Subject: Draft Final Technical Study of Spent Fuel Pool Accident Risk at
Decommissioning Nuclear Power Plants, February 22, 2000 (65 F.R.
8752), Request for Comments

**Industry Comments
NRC Draft Final Technical Study of
Spent Fuel Pool Accident Risk at
Decommissioning Nuclear Power Plants**

**Comments on Appendix 2.b.
“Structural Integrity Seismic Loads”**

Figure 1 – Distribution of Upper Bound Magnitude Estimates from Reference 2 for a New England site.

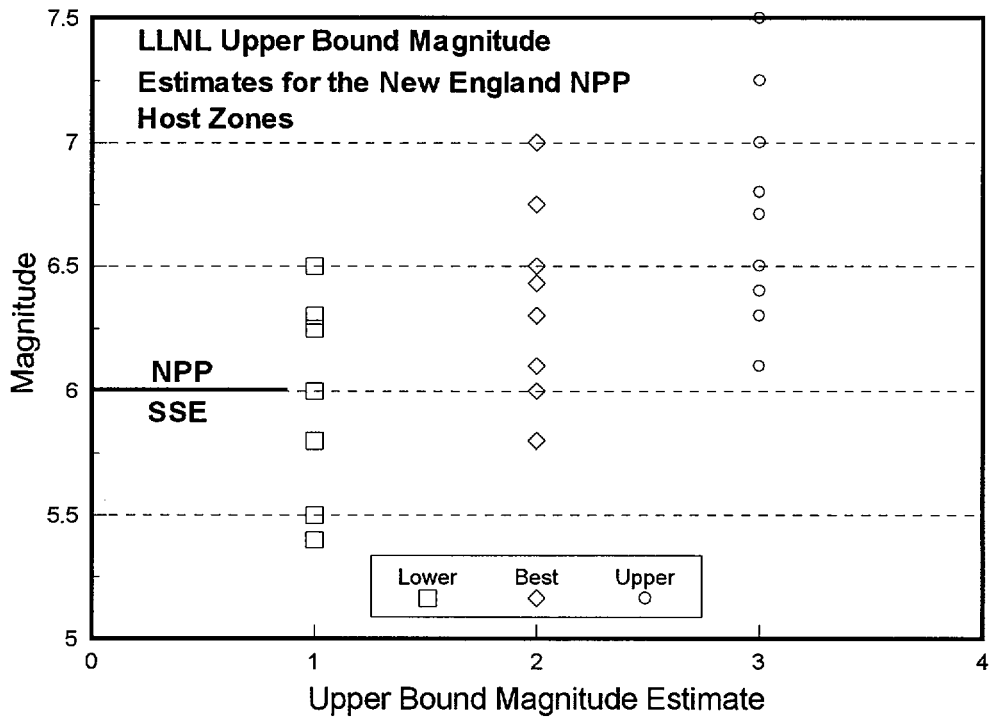
References 2 and 3 describe the Lawrence Livermore National Labs (LLNL) and Electric Power Research Institute (EPRI) seismic hazard methodologies. A seismic hazard analysis (SHA) estimates the seismic hazard at a site due to the potential occurrence of earthquakes in the region surrounding the site. Importantly, the historic seismic data is insufficient, at least for the CEUS, to use as the sole source of information for estimating the various parameters of the overall probability model. Therefore, it is necessary to rely on “expert opinion” to supplement the data. One fundamental expert opinion input to the SHA is the upper bound magnitude distribution for each earthquake source. Figure 1 contrasts the distribution of upper bound magnitude estimates assessed by the experts in the LLNL study for the host zones containing a New England NPP with the SSE determined by the 10CFR Part 100 Appendix A process. This distribution of upper bound magnitude may be plausible, but not necessarily a possible outcome. In other words, it is not based on any known structure in each host zone description that could cause earthquakes this large. Within this context, the assessed seismic hazard will generally be higher – because less is known and the distribution has more probability associated with extreme outcomes, **or, outcomes that in fact cannot occur**. The effect of including these extreme outcomes is to predict incredible ground motions at credible probability levels. Expert opinion on the distribution of upper bound magnitude is but one of the many opinions rendered in the LLNL and EPRI studies that have profound effects on the perceived seismic hazard at low (10^{-6}) probability levels.

Figure 2 Effect of Attenuation Random Uncertainty on Probability of Exceedance from a Point Source

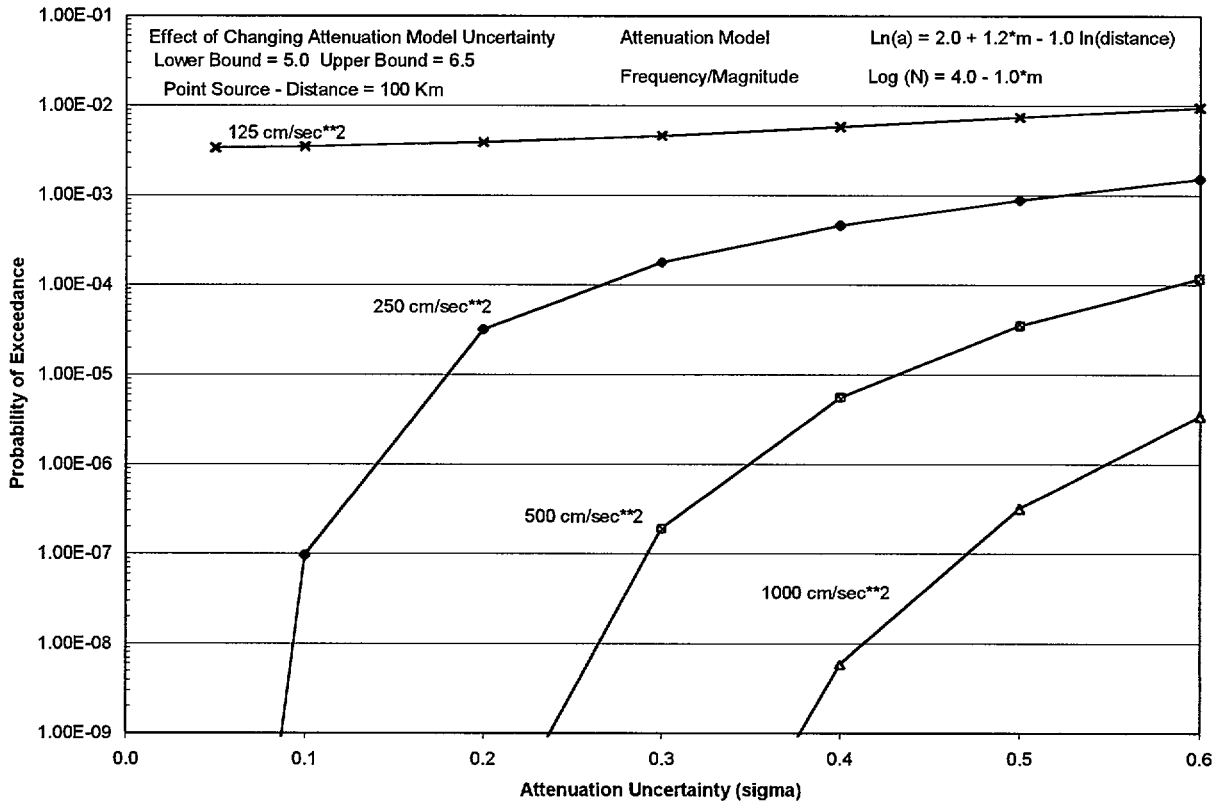
Successful application of the revised seismic checklist provides a high degree of assurance that the SFP HCLPF is 0.5g or greater. It is noted that given a HCLPF of 0.5g the median capacity of an SFP is about 1.0g. Realistically, only large Charleston like earthquakes can generate ground motions of the amplitude, frequency content, and duration to challenge the seismic capacity of spent fuel pools. In no EUS licensing proceeding has there been compelling data to require design to an earthquake of a magnitude which would challenge the seismic capacity of an SFP that satisfies the seismic checklist. The focus of previous seismic hazard studies (LLNL and EPRI) has been at the SSE level. At high ground motion values (ground motion values that can be associated with damage to SFPs), the tail of the attenuation random uncertainty distribution (sigma) allows, with some non-negligible probability, relatively small events to contribute to the

probability of exceeding these high ground motion values. These results don't make sense and provide a basis for truncating the tail of the random uncertainty term at high ground motion values. In deterministic analyses used in the licensing of existing NPPs, one standard deviation is considered sufficient to incorporate all the conservatism in the final ground motion estimate. Based on this information and information previously described in Reference 5, use of the LLNL probabilistic estimates at low probability values may not be credible. EPRI results are also likely to be overly conservative at high ground motion values.

Figure 3 – Annual Probability of Exceeding the SSE at CEUS sites based on EPRI (Reference 3)

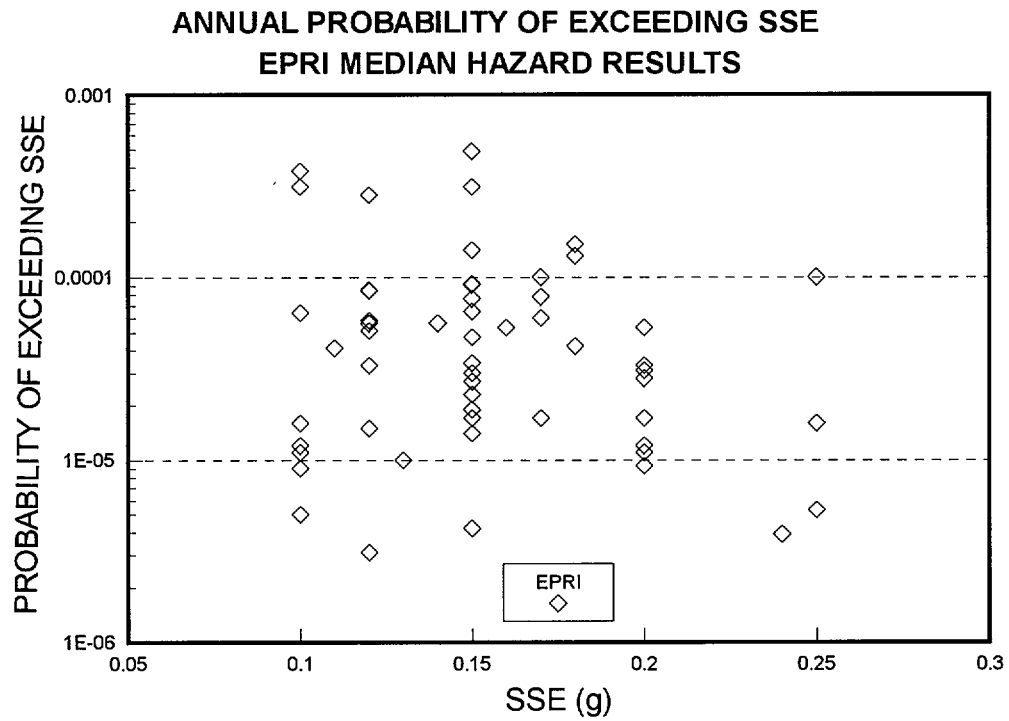
The staff concludes that for those CEUS plants where 3 X SSE is less than or equal to the NEI screening criterion of 0.5g, then the seismic risk is acceptable low. A similar conclusion is reached for those WUS plants where 2 X SSE satisfies the screening criterion. For CEUS plants that exceed the 3 X SSE screening criterion, a detailed SFP assessment will be required to demonstrate the SFP HCLPF equals 3 X SSE. A similar conclusion is reached for those WUS plants where 2 X SSE exceeds the screening criterion. This requirement that some plants with higher SSE values perform detailed HCLPF assessments of their SFPs is not warranted. The assumption of this requirement is that the SSE is correlated with seismic hazard, in other words, the higher the SSE the higher the seismic hazard. Previous studies have shown that the SSE is poorly correlated with the seismic hazard (see Figure 3). In particular, there are many 0.2g to 0.25g SSE sites with lower seismic hazard estimates than 0.1g to 0.2g SSE sites. SSE tends to be more correlated with plant vintage than seismic hazard. **Based on this information, we**
